**Response to the “Approval with Modifications, Phase II Investigation Report,
Material Disposal Area (MDA) T at Technical Area (TA) 21, Revision 1.0,
EPA ID No: NM0890010515, HWB-LANL-08-005,”
Dated March 28, 2008**

Figure 3.2-1 Location of vapor-monitoring wells and abandoned boreholes at MDA T

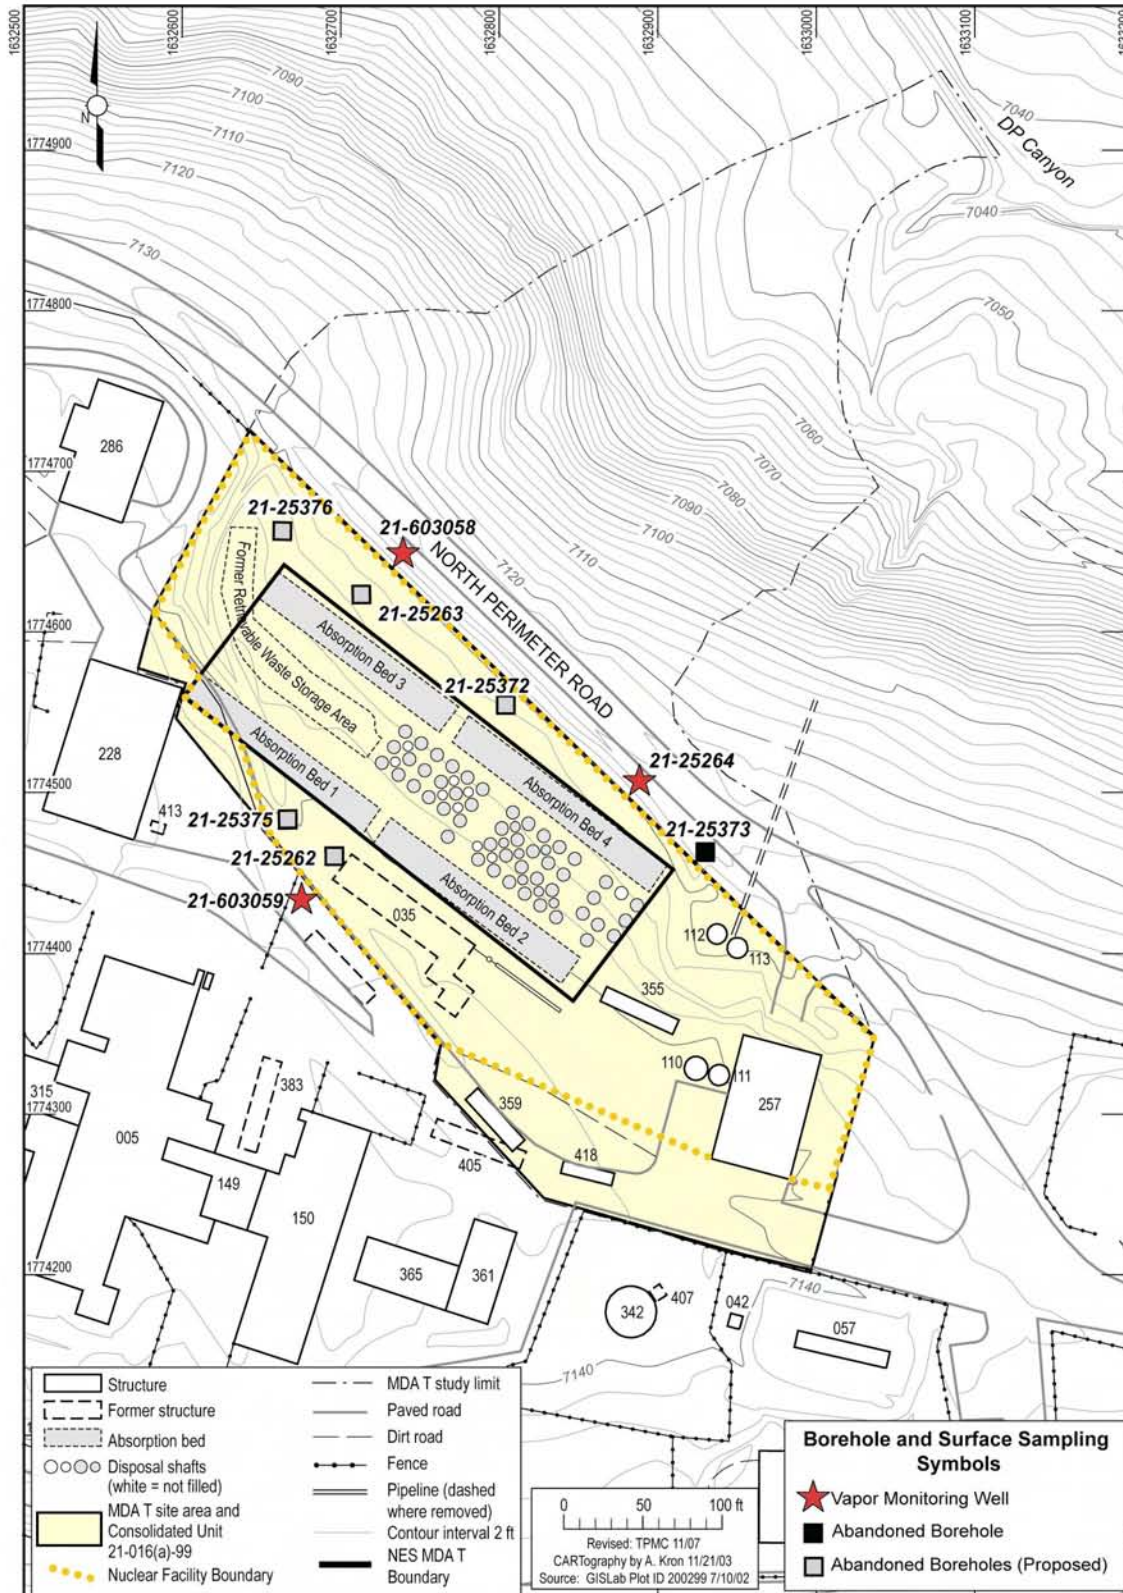
The Permittees failed to provide in the revised Report documentation (e.g., a Document Safety Analysis or an equivalent reference) to explain how and why the status of the work area at MDA-T changed from designation as a nuclear environmental site to a nuclear facility. NMED explicitly stated in the February 22, 2008 meeting with LANS contractor Kevin Reid and Bruce Wedgeworth of your staff that specific documentation must be submitted to explain the new designation and to justify the Permittees need to install substitute investigation boreholes 21-603058 and 21-603059. Since the Permittees did not adequately justify the need for the deviation, the Permittees must collect pore-gas samples from all five borehole locations (21-25262, 21-25263, 21-25264, 21-603058, and 21-603059) for the remainder of the quarterly sampling events. This must include the removal of the slough from boreholes 21-25262 and 21-25263, as originally required by NMED in the February 2007 Phase II Investigation Work Plan for MDA-T (referenced by LA-UR-07-0930/EP2007-0105), and the installation of permanent vapor monitoring wells equivalent to those installed in borings 21-25264, 21-603508, and 21-603059.

Material Disposal Area (MDA) T has been a nuclear facility and a nuclear environmental site (NES) since November 2003 (DOE 2003, 087047). The attached figure, Figure 3.2-1 from the February 2008 Phase II investigation report (IR), revision 1 (LANL 2008, 102182), clearly shows these boundaries. LANL acknowledges that the original figure from the 2006 MDA T IR (LANL 2006, 094151) was unclear regarding the NES and nuclear facility boundaries because the nuclear facility boundary had not been identified. However, NMED's assertion that the status of the work area at MDA T changed its designation from a nuclear environmental site (NES) to a nuclear facility is not correct. There was no change, no deviation, or no new designation for the work area: the boreholes in question (21-25262 and 21-25263) were always within the nuclear facility boundary. Because the boreholes were within the nuclear facility boundary and additional time was needed to prepare for well installation, LANL requested moving each of the boreholes to immediately outside the nuclear facility boundary. (NMED granted the request in a phone call and an e-mail on October 26, 2007.) This request was discussed in detail with NMED during the meeting on February 22, 2008. Specific safety basis documentation can be provided, if needed.
